Planning Commission Minutes  
February 22, 2024

**STAFF REPORT**  
**The City of Oklahoma City**  
**Planning Commission**  
**February 22, 2024**

**(SPUD-1593) Application by Lilyfield Inc. to rezone 1841 Exchange Avenue from R-1 Single-Family Residential, C-3 Community Commercial, C-4 General Commercial, and SRODD Scenic River Overlay Design Districts to SPUD-1593 Simplified Planned Unit Development and SRODD Scenic River Overlay Design Districts. Ward 6.**

**Agenda Item** VII.A.  
**Case No.** SPUD-01593  
**Property Address** 1841 Exchange Ave  
**Applicant Name** Dean Koleada, Civil & Environmental Consultants Inc.  
for Holly Towers, Lilyfield Inc.  
4700 Gaillardia Pkwy, Ste 101  
Oklahoma City, OK 73142

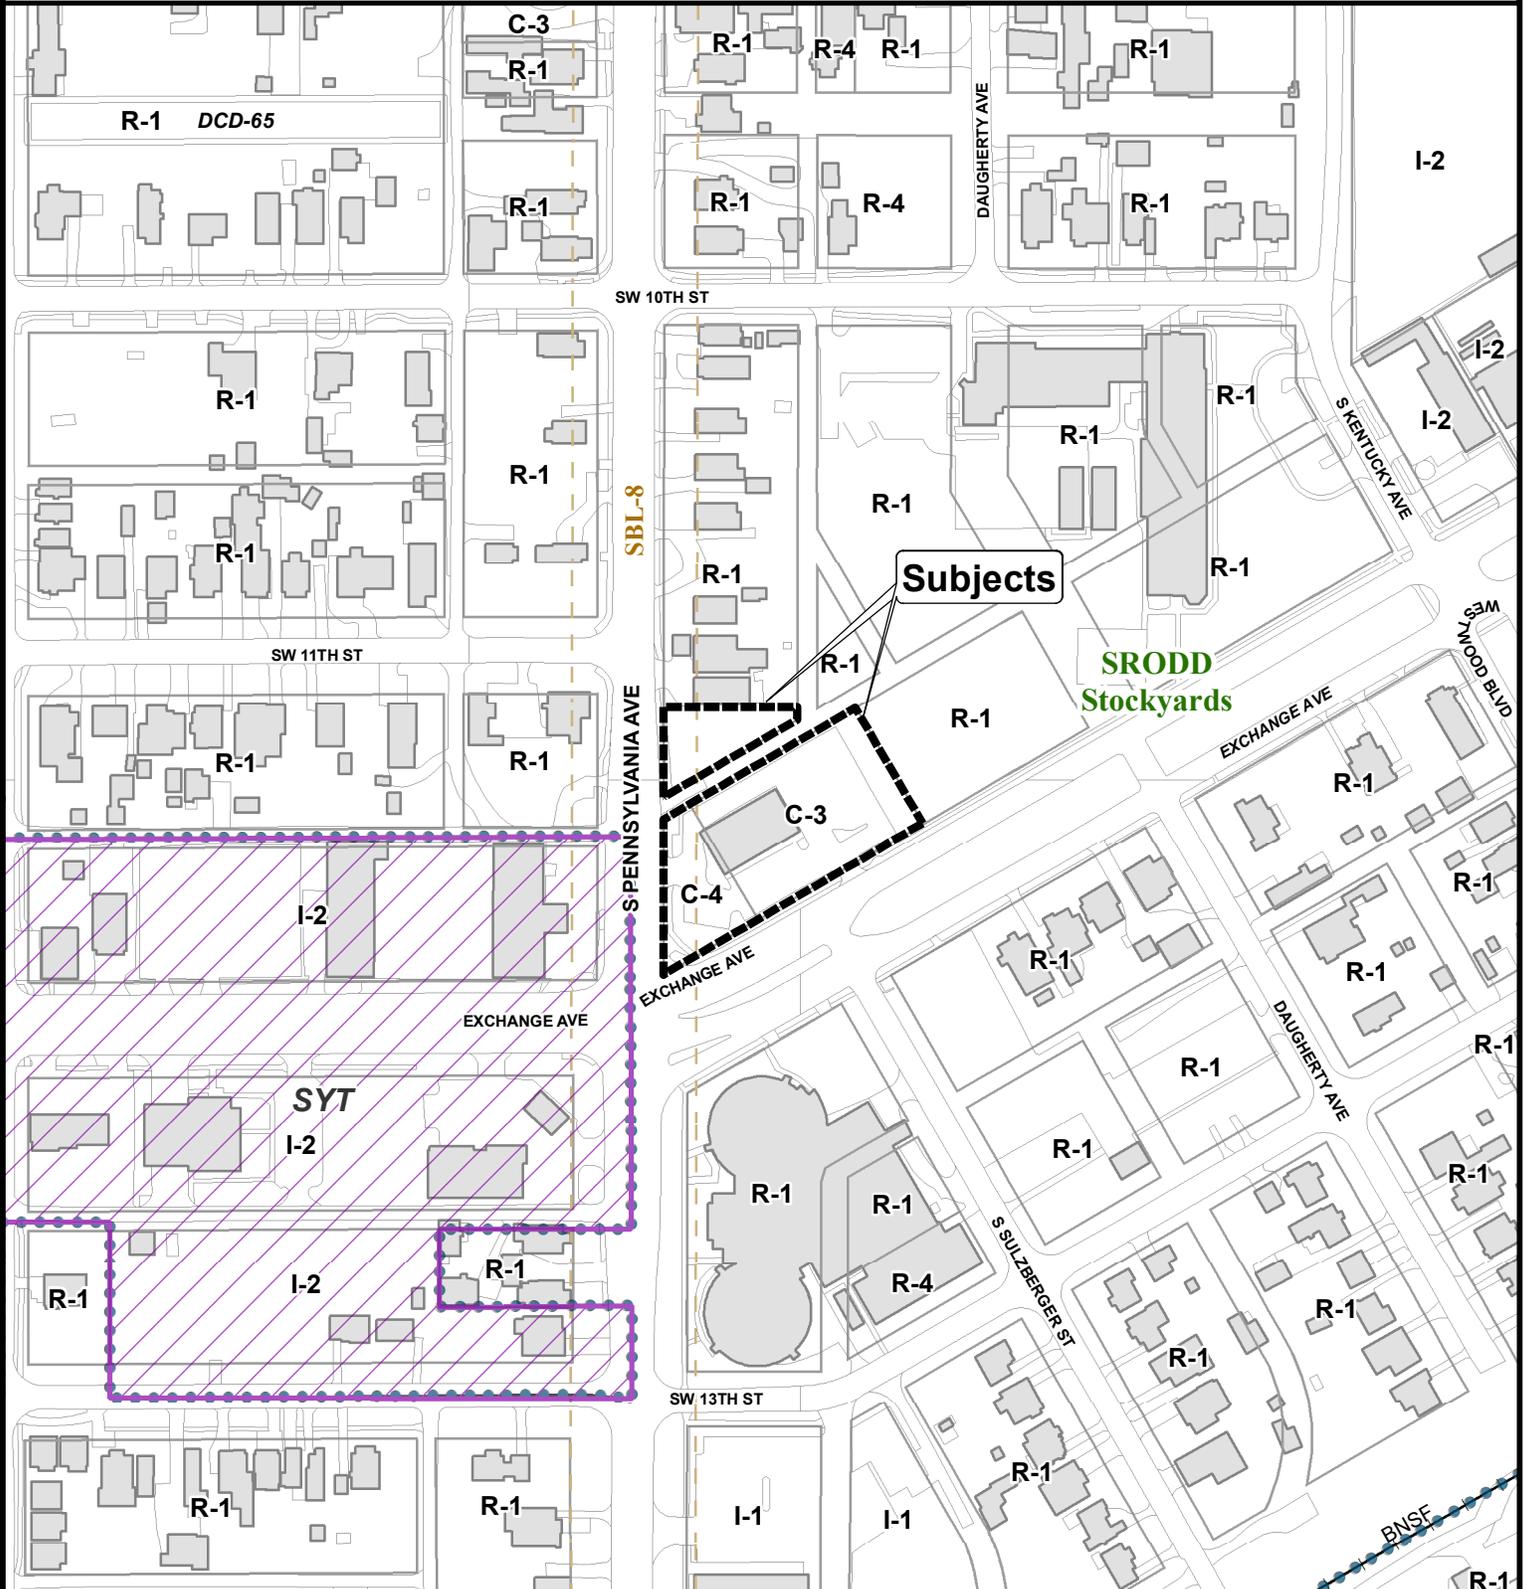
c) **Re: Proposed alley closure/vacation**

- 1) Description: The applicant has indicated the desire to close the alley with the City of OKC and vacate same in District Court. To

date, the required CE application has not been submitted, although the Site Plan submitted reflects the alley being vacated.

- 2) Considerations: The Site Plan depicts the current alley right-of-way being utilized for the driveway, parking spaces, and landscaping (no specifics shown at this time). The alley contains a City public sewer line and an OG+E overhead electric line. The location of the power poles for this overhead electric line are not clearly depicted on the Site Plan. These power poles will have to be located in a landscape island to protect vehicles. The attached marked-up Site Plan shows the alley right-of-way the applicant will be requesting to be closed and vacated.

Staff is concerned about a closure of the alley in this location because of the impact on connecting alleys in this area. The subject east/west alley has several north/south alleys that extend northward from it. The issues for closure of the subject alley will be discussed at the time the required application is submitted. It is possible that modifications to the parking lot/site layout will be required if the closure is not approved.
